SUNDRY NOTICES AND REPORTS ON WELLS
Do not use this form for proposals to drill or to re-enter an abandoned well. Use Form 3160-3 (APD) for such proposals.

Zachary Oil Operating Co
Stanolnd Federal #1
API 30-025-06212
WBD Before PA

Permanent Abandonment of Federal Wells
Conditions of Approval (LPC Habitat)

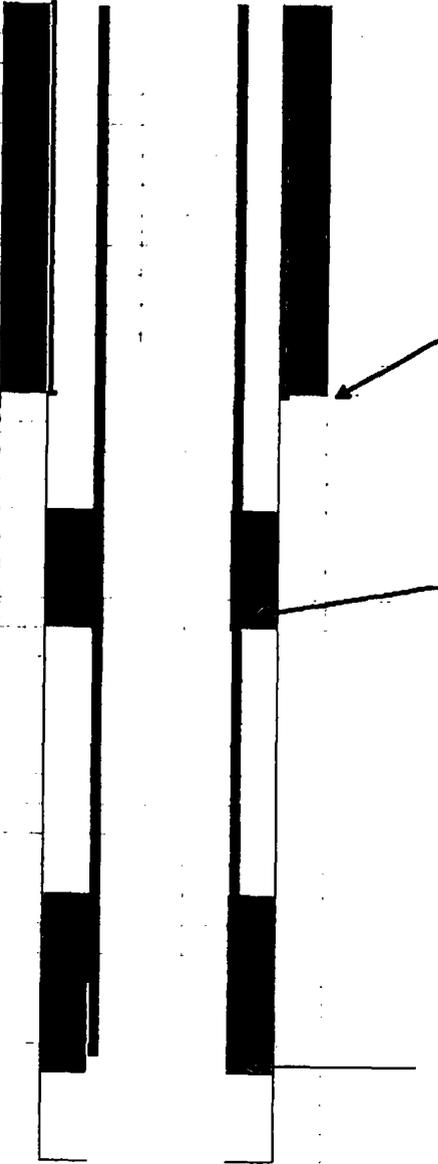
Below ground level dry hole marker required

8 5/8" 32# casing ✓ 2/2
Cemented w/125 SF ✓
TOC @ Surface ✓

DV Tool @ 1270
ETOC @ 813' @

5 1/2" 15.5# ca
Cemented w/1
ETOC @ 3066'
Open Hole 352
